CYPRESS COVE SUBDIVISION

APPLICATION NUMBER 1 DATE November 1, 2007

DETAIL SITE PLAN

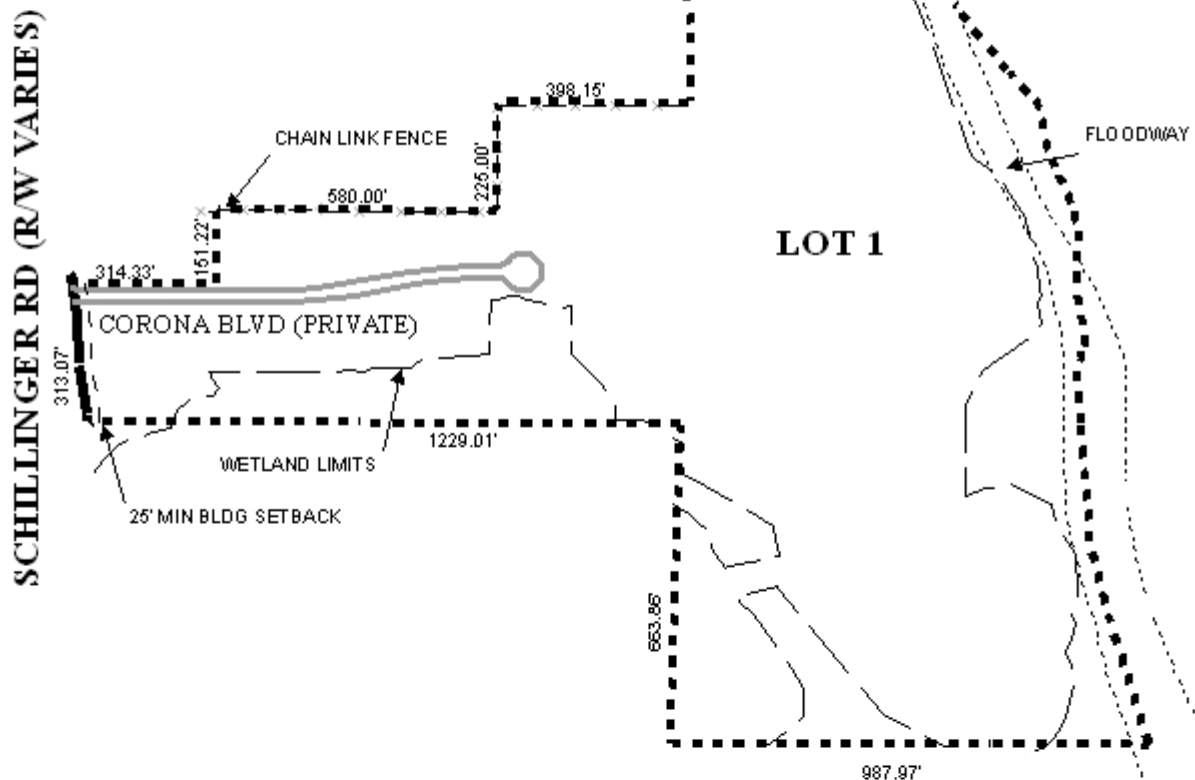
The required 25' minimum building setback line is shown on the plat but not identified as such; therefore the minimum building setback line should be shown and indicated along Schillinger Road South and all Western boundaries of the site. The plat was labeled with the area in acres and this should also be included on the final plat or a table depicting the same information should be provided.

The application was heldover from the October 4th meeting, to allow the applicant to address several issues. A revised plat was submitted addressing most of the deficiencies in the original plat, except the inclusion of the remainder of the two parcels to the East, which was a major concern and reason for the holdover.

Since the portions of those parcels included in this application were separated from the parent parcels via metes and bounds deeds without the proper Subdivision process, inclusion of the remainder of the parent parcels in this application is required. As the revised plat did not illustrate inclusion of the remainder of the parent parcels, and since the legal description of all the included properties was not revised to indicate inclusion of the remainder of the parent parcels, this application does not meet the requirements of the Subdivision Regulations and should not be considered for approval.

- 8) depiction and labeling of the 25' minimum building setback line along Schillinger Road South and all Western boundaries of the site; and
- 9) labeling of the lot with its area in acres or the provision of a table on the plat depicting the same information.

- 1. by not including the entire parent parcels (or submitting documentation to establish them as parcels of record prior to July 1984), the plat does not include the entire property being subdivided, and therefore does not comply with the requirements of the Subdivision Regulations.*
